Diesel services incompatible with 2013 and newer 2.0 VW TDI

February 22, 2016 || 16-400

Jet Body w/ Check Valve

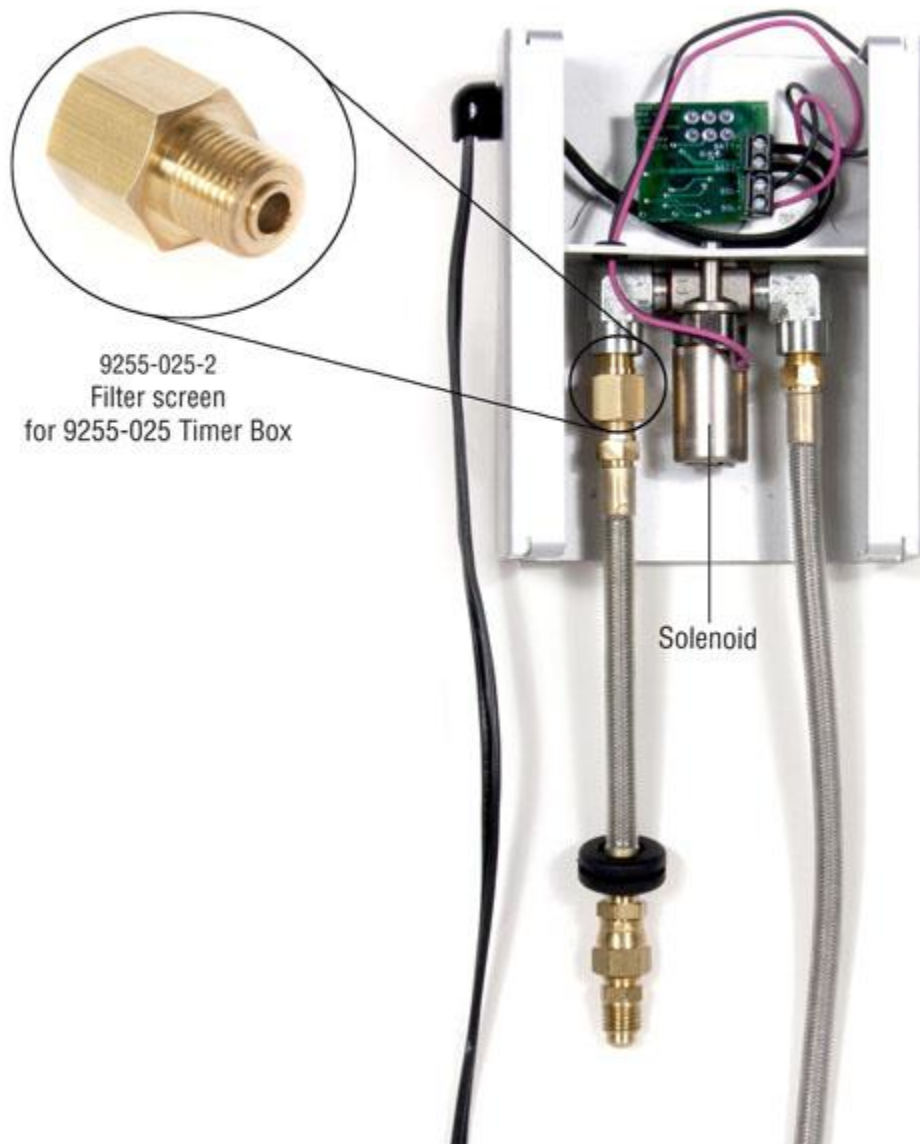
On certain applications, the current Jet Body w/ Check Valve (90-degree), PN 9255-033, does not allow for a convenient hookup due to limited clearance. The Jet Body w/ Check Valve (Straight), PN 9255-054, allows a configuration option that may be more convenient. The 9255-054 will now be included with Ford 6.4L EGR System Service Adaptor, PN 9255-048.

Examples of cracks in the threads of the 9255-036 spray nozzles

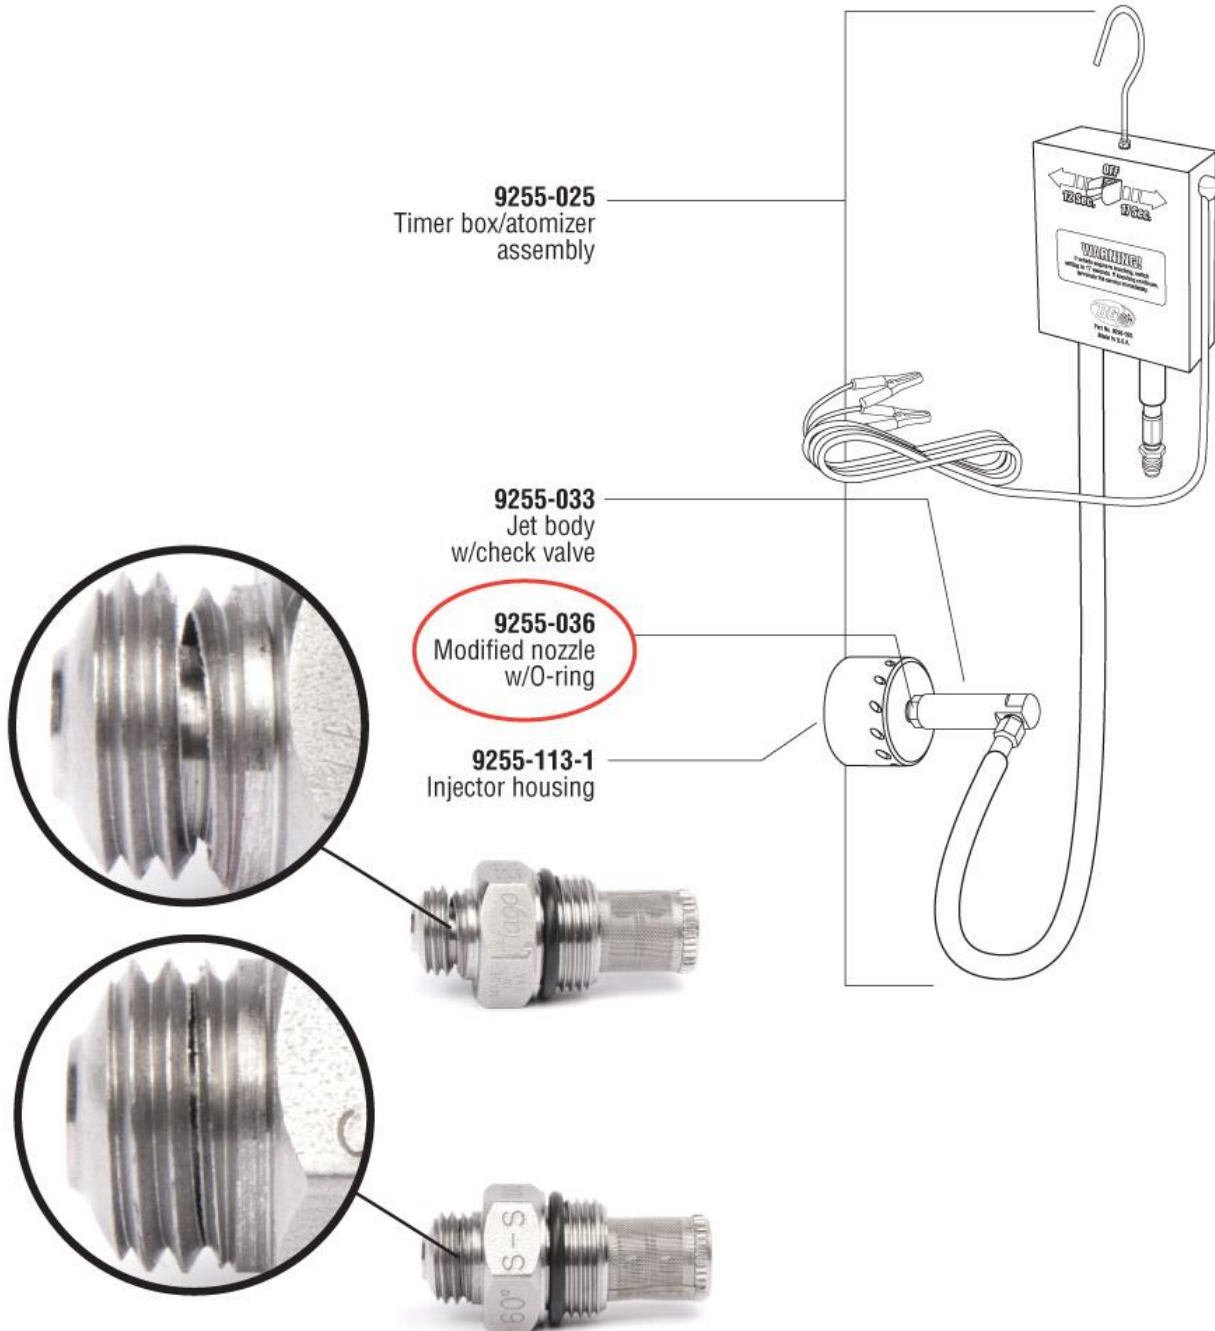
Please examine ALL 9255-036 spray nozzles (part of the 9255-025 Timer Box assembly in the BG Diesel Induction Service Set, PN 9255-550) in your inventory to make sure that the threads are not cracked (see photos). If spray nozzle is cracked, it can cause product to be delivered at an extremely fast rate and possibly cause catastrophic engine damage.

If you find any cracked spray nozzles, please contact BG Customer Service.
